APPLICATION NUMBER: 25/1052

PROPOSAL: RESERVED MATTERS APPLICATION RELATING TO LAYOUT, SCALE, APPEARANCE, ACCESS AND LANDSCAPING FOR RESIDENTIAL DEVELOPMENT AT PHASE4E/4G

SITE: Glan Llyn Development Site Phase 4E/4G Queensway Llanwern

Engineering plan extract showing bioretention strips to all front and rear gardens

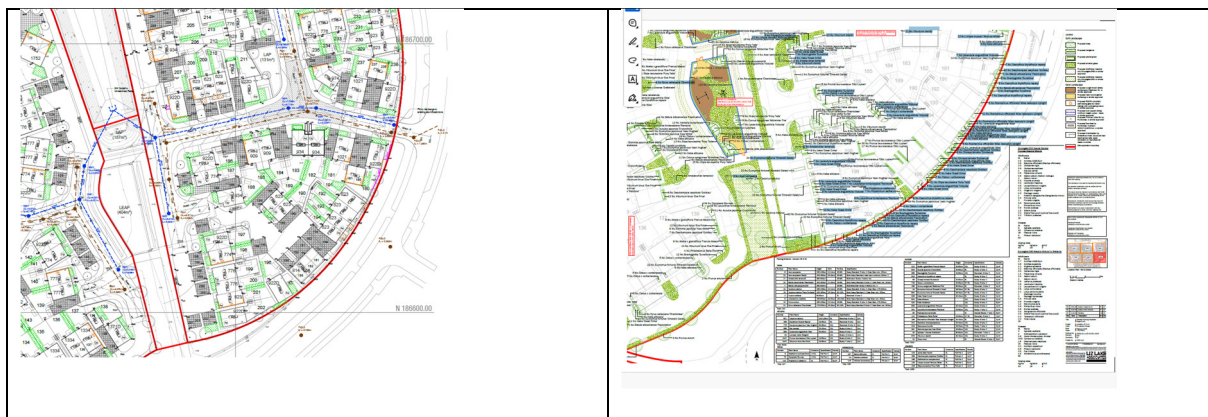
The engineering plans show extensive bioretention areas to **all front gardens** which are not reflected in the Detailed Planting Proposals. The species proposed which includes lavender, ceanothus etc may not cope with the conditions. This needs clarification.

The engineering plans show extensive bioretention areas to **all rear gardens** which are also not reflected in the Detailed Planting Proposals. The areas are not shown as planted so presumably these will be grassed but as these will be privately maintained the slopes need to be clarified. Note that the proposals would remove significant useable space from already small rear gardens – refer to extract below. This needs clarification.

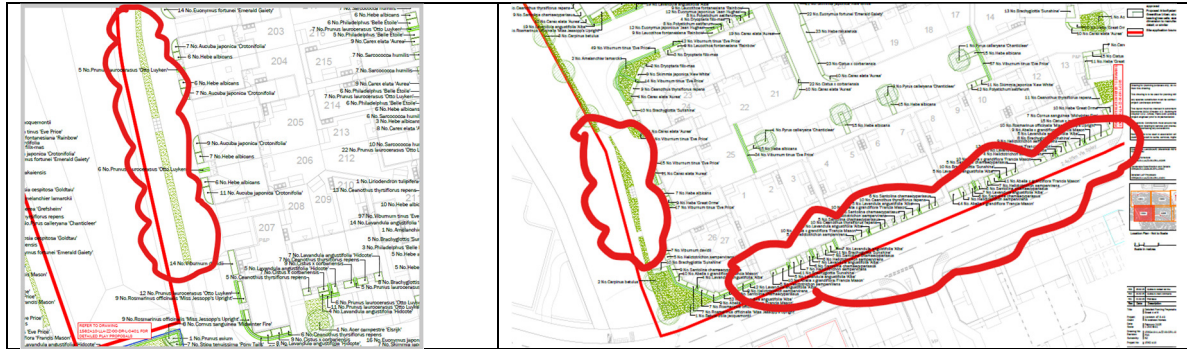
The Detailed Planting Proposals show swales around the LEAP to be seeded with a wetland mix, however these are not detailed on the Engineering Layout or in the SUDs details – see extracts below. Slope gradients are unclear and require clarification to steer maintenance.
